October 4, 2021

**RE: Transport Housing Apartments
Conceptual Grading and Drainage Plans
Engineer's Stamp Date: 08/25/21
Hydrology File: M15D023H**

**RE: RESPONSE TO HYDROLOGY COMMENTS
TRANSPORT HOUSING APARTMENTS, 2900 TRANSPORT ST. SE
CONCEPTUAL GRADING & DRAINAGE PLAN**

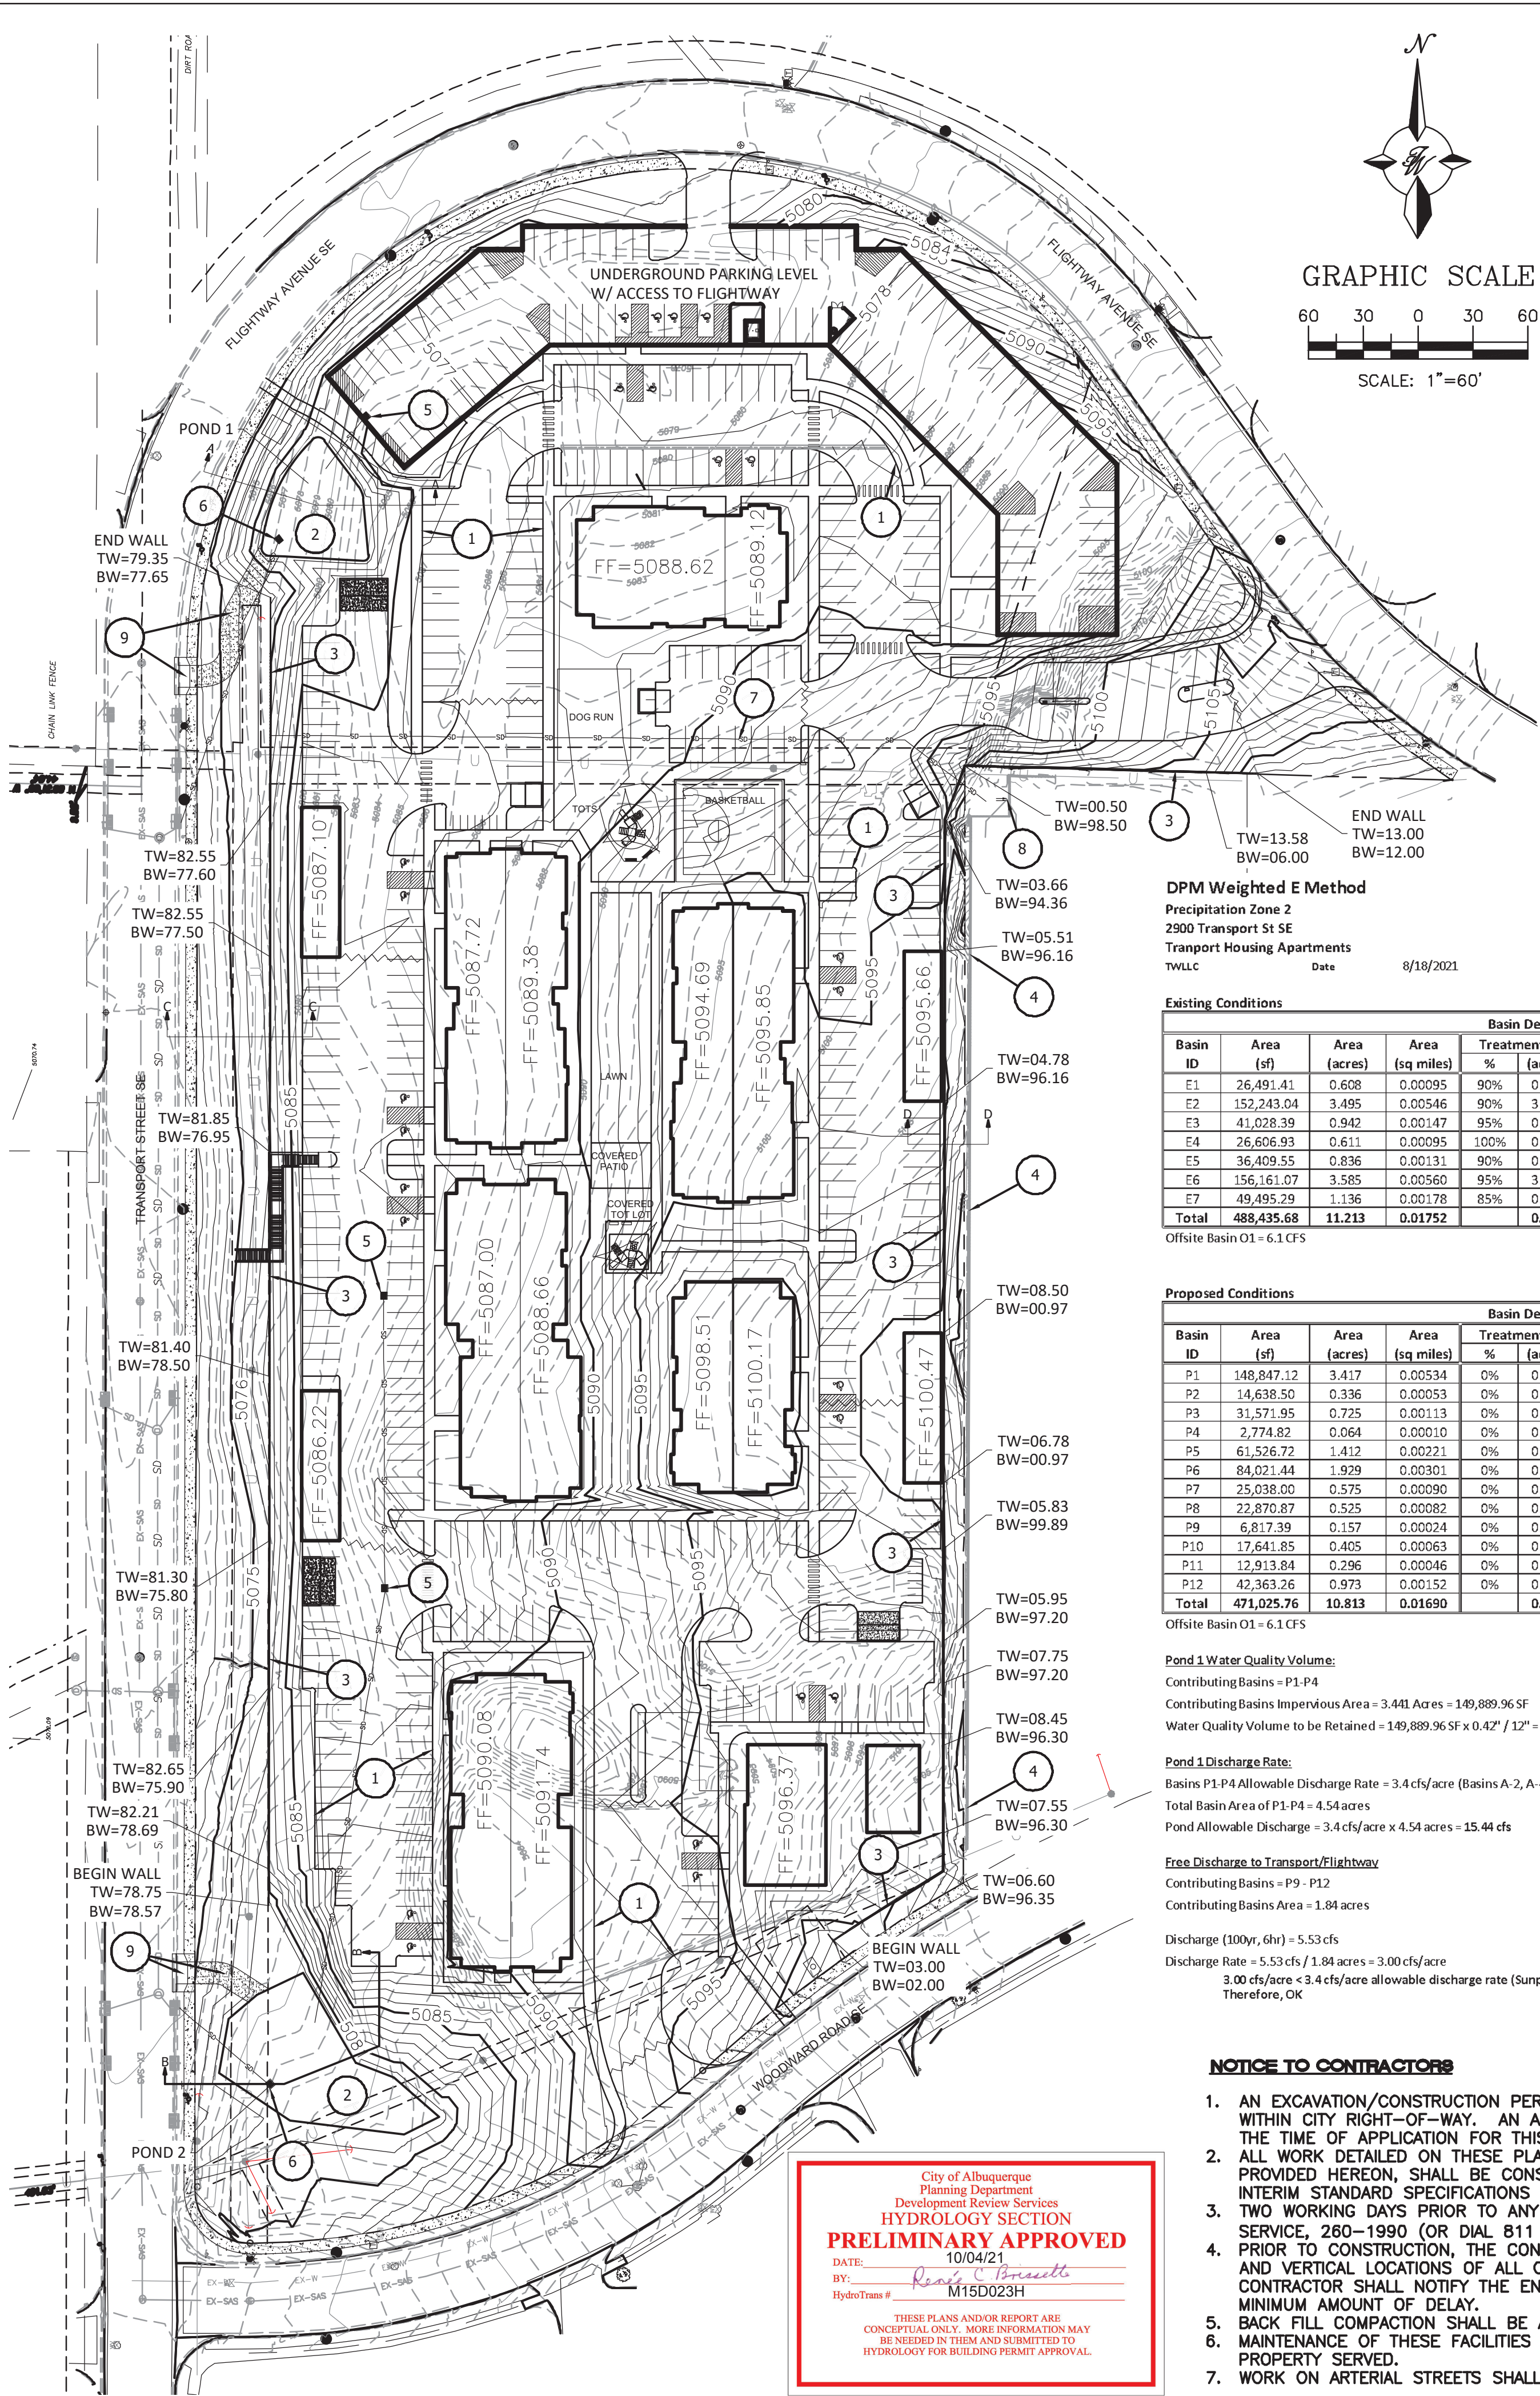
2. The existing Comfort Inn currently has a discharge of 6.1 cfs that needs to be added to the existing conditions and somehow needs to be allowed to pass through the site. This may be just picking up the drainage and piping it to Flightway or Transport.

5. Sheet 2.1. Please show maintenance ramps for each detention ponds. Also show a driveway for each pond.
Response: Maintenance ramps and drive pads are now shown on Sheet 2.1 with Keyed Note 9 calling these out.

Response: Basin O1 for the hotel is now shown on both basin maps along with the outfall location and discharge rate. The Weighted E table also shows this basin note that 6.1 cfs comes from this basin. A 12" HDPE storm drain has been added to pick up this drainage and pass through the site and daylight through the western proposed retaining wall and ultimately discharge into Transport Street. Keyed Notes 7 and 8 call these out on Sheet 2.1.

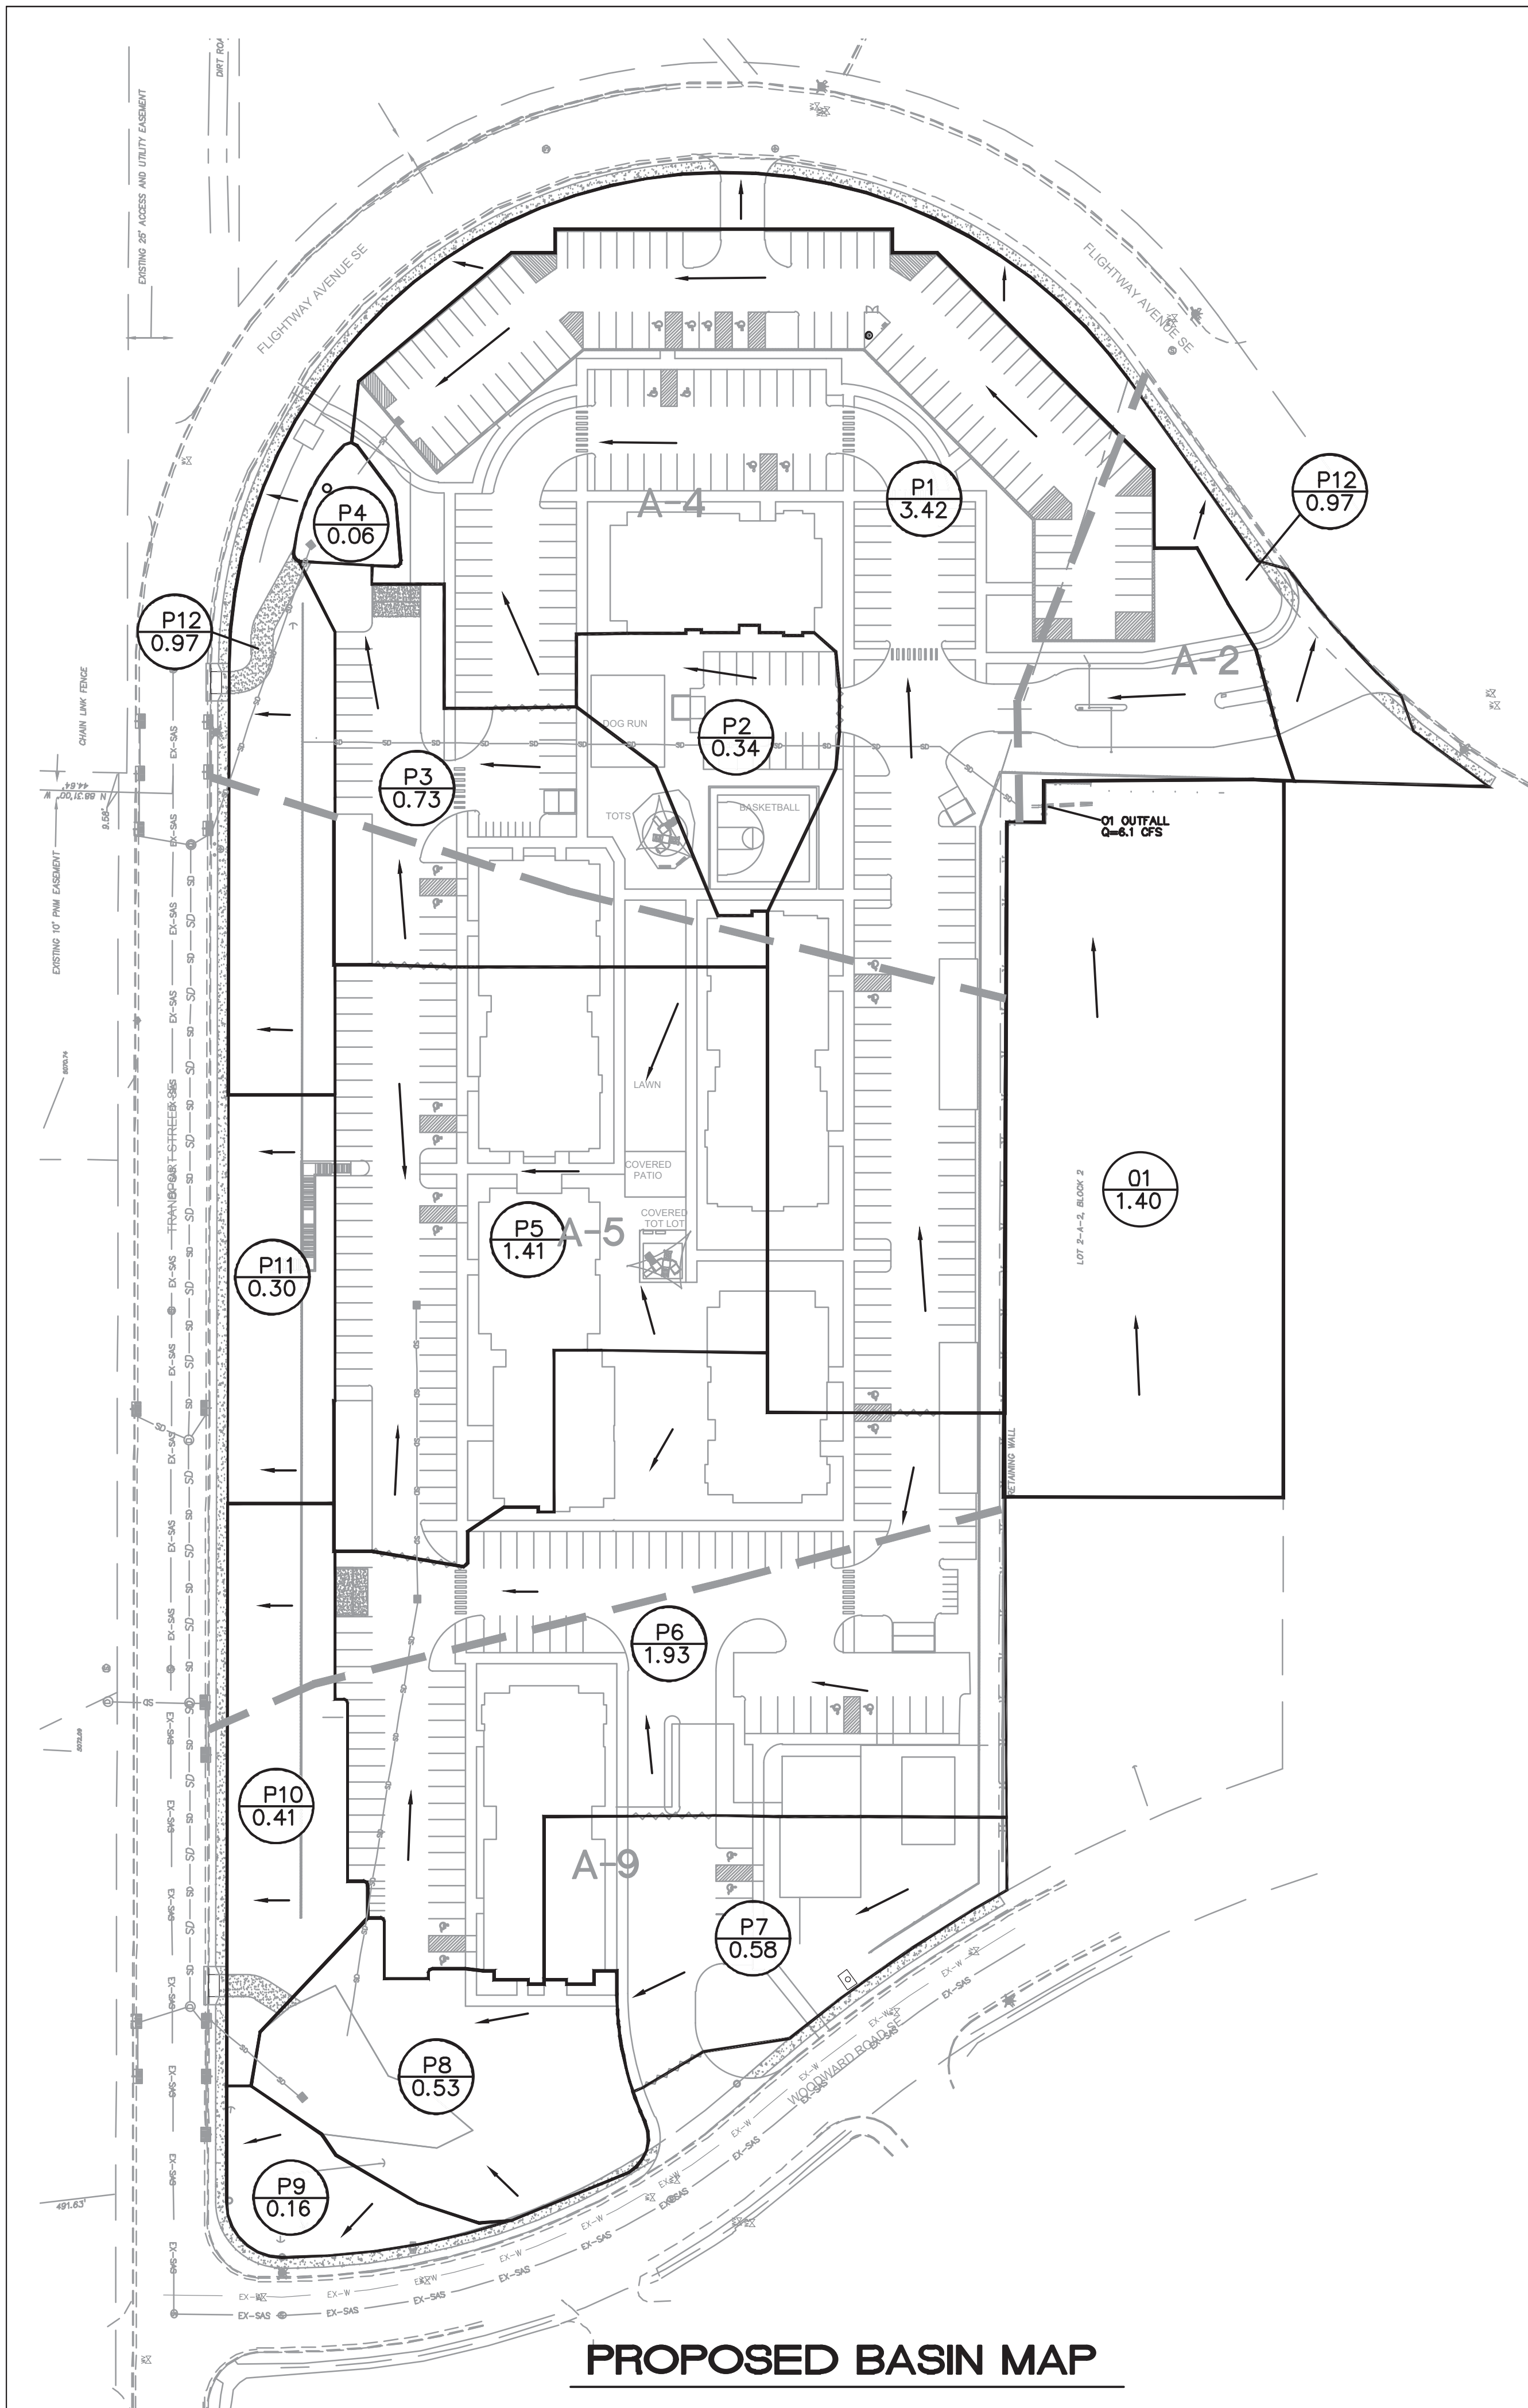
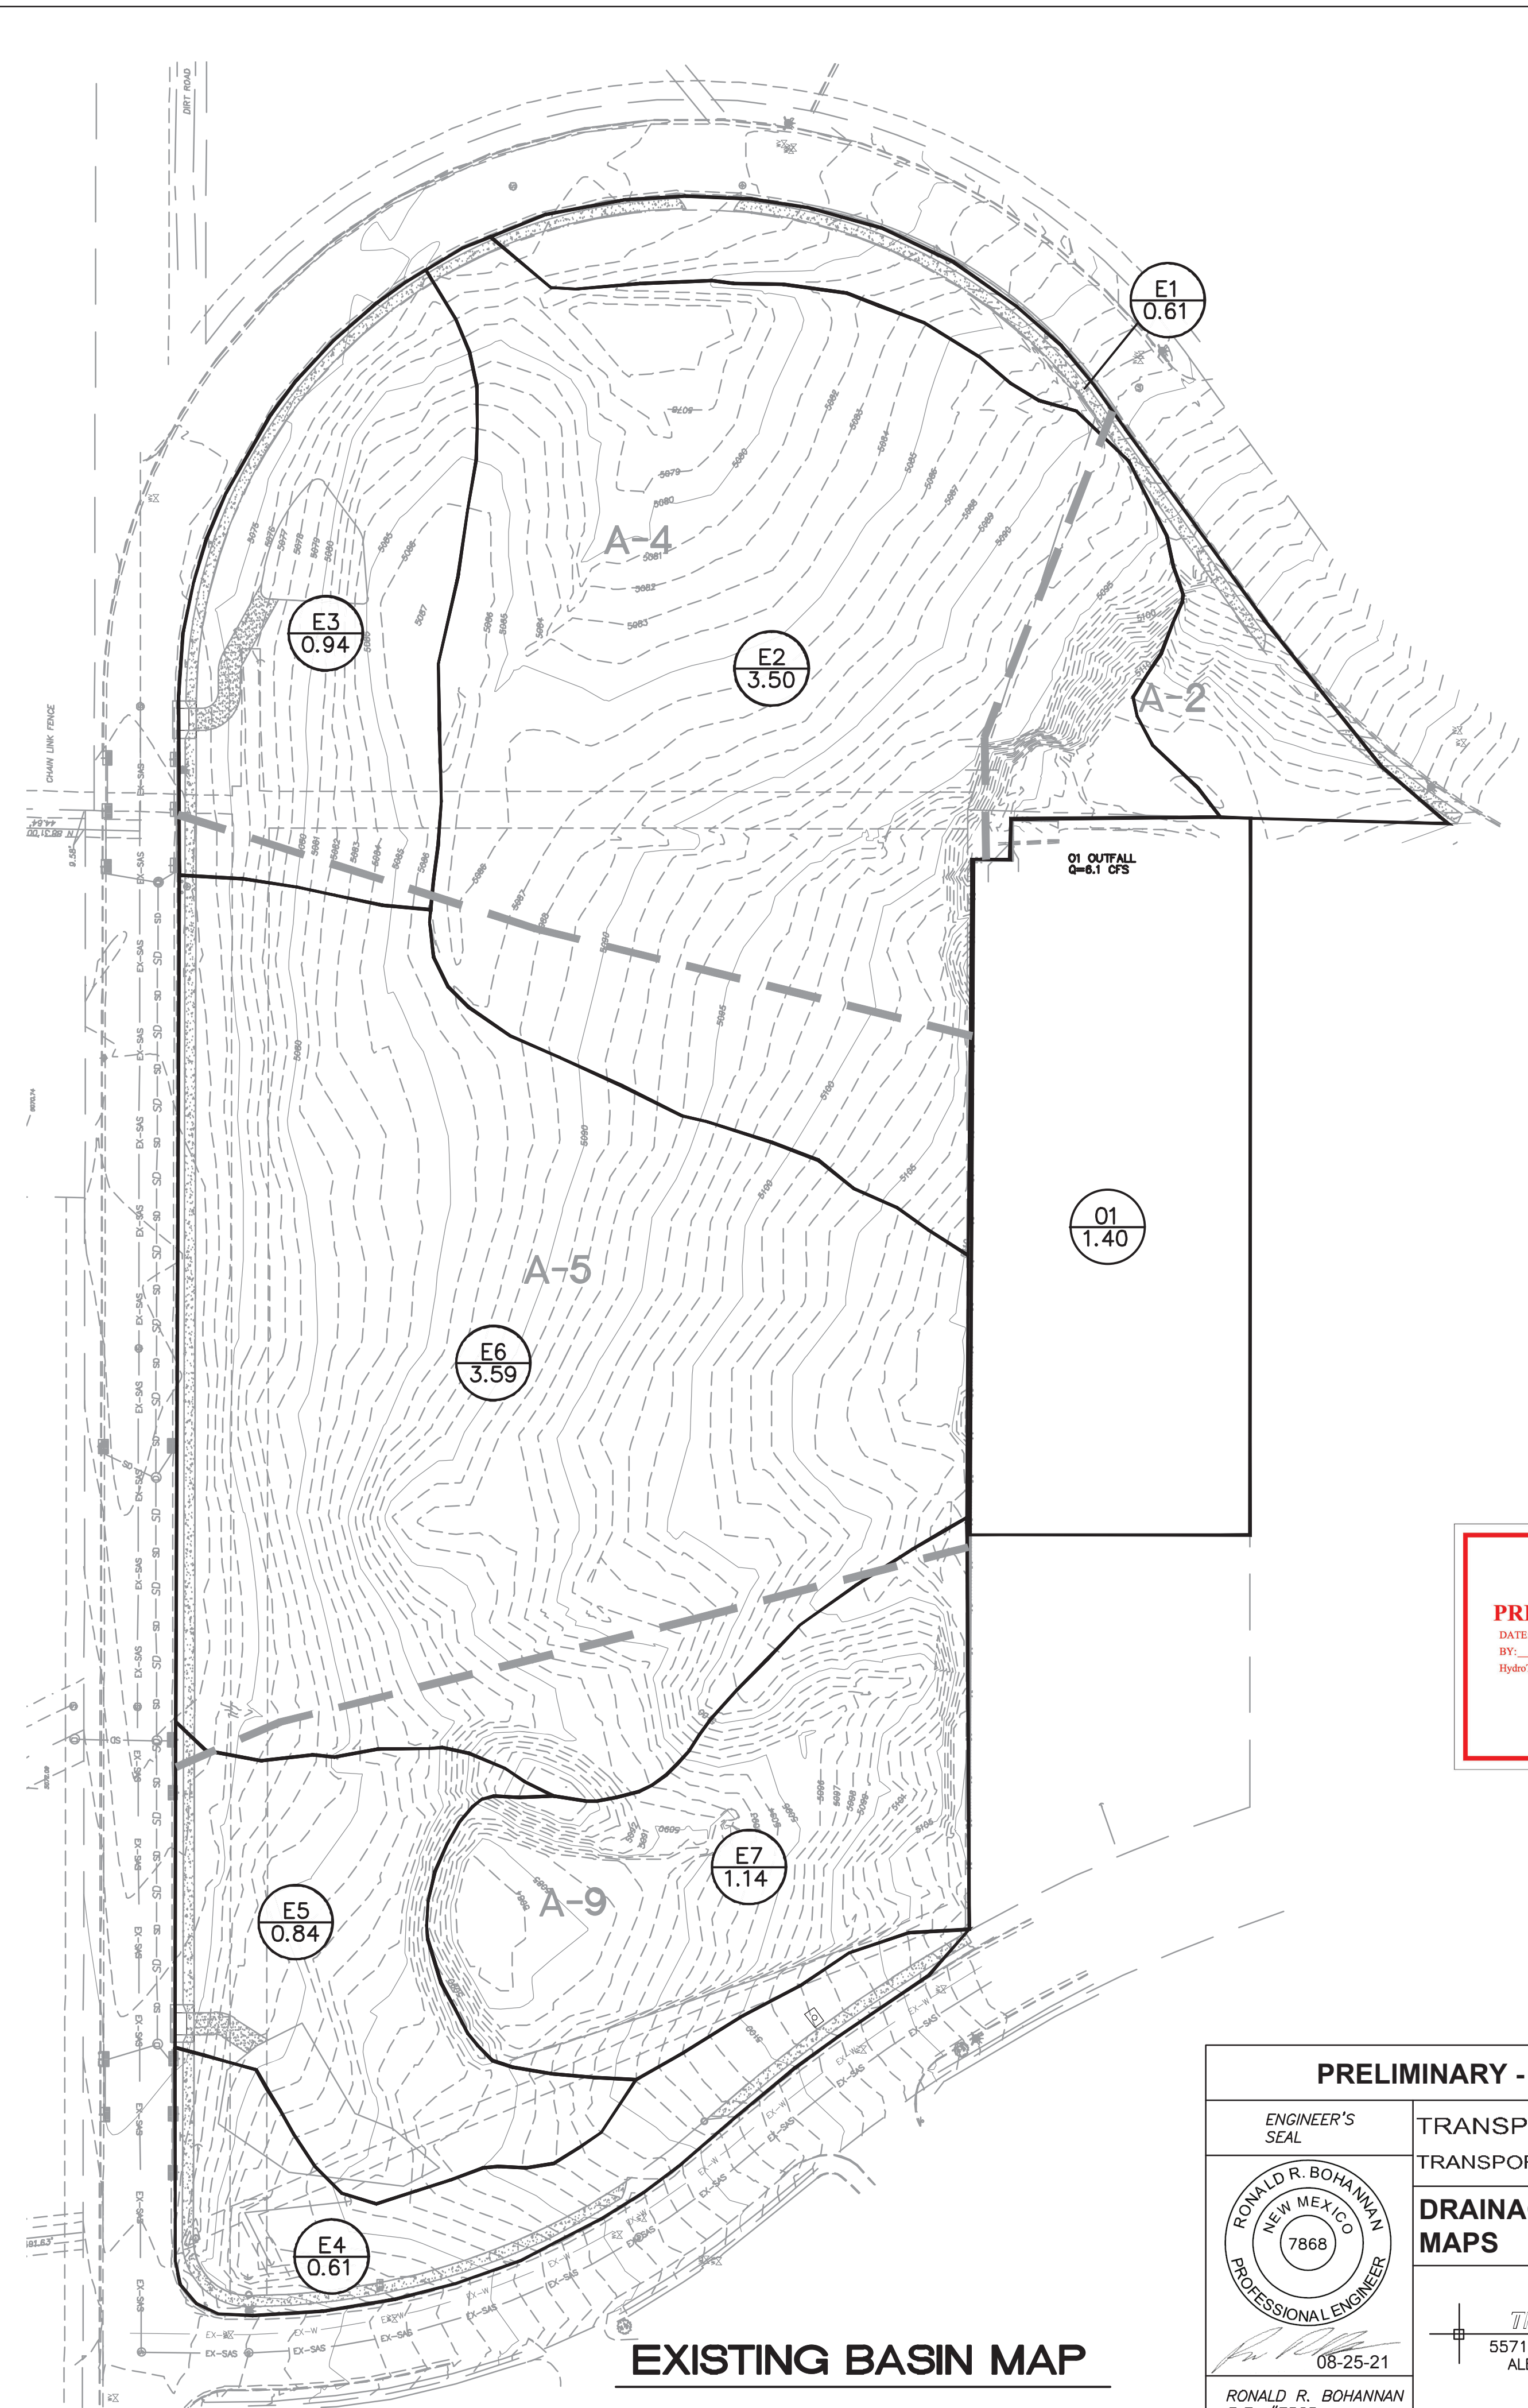
1. Sheet 2.2. Please add the existing basins that correspond to Sunport Phase 1 Master Drainage Plan to both the existing and the proposed basins.
Response: These basins are now shown on both basin maps on Sheet 2.2.

4. Sheet 2.2. Please add some drainage arrows on the proposed drainage basins showing how each area will drain to the respected detention pond.
Response: Flow arrows have been added to the proposed drainage basin map.
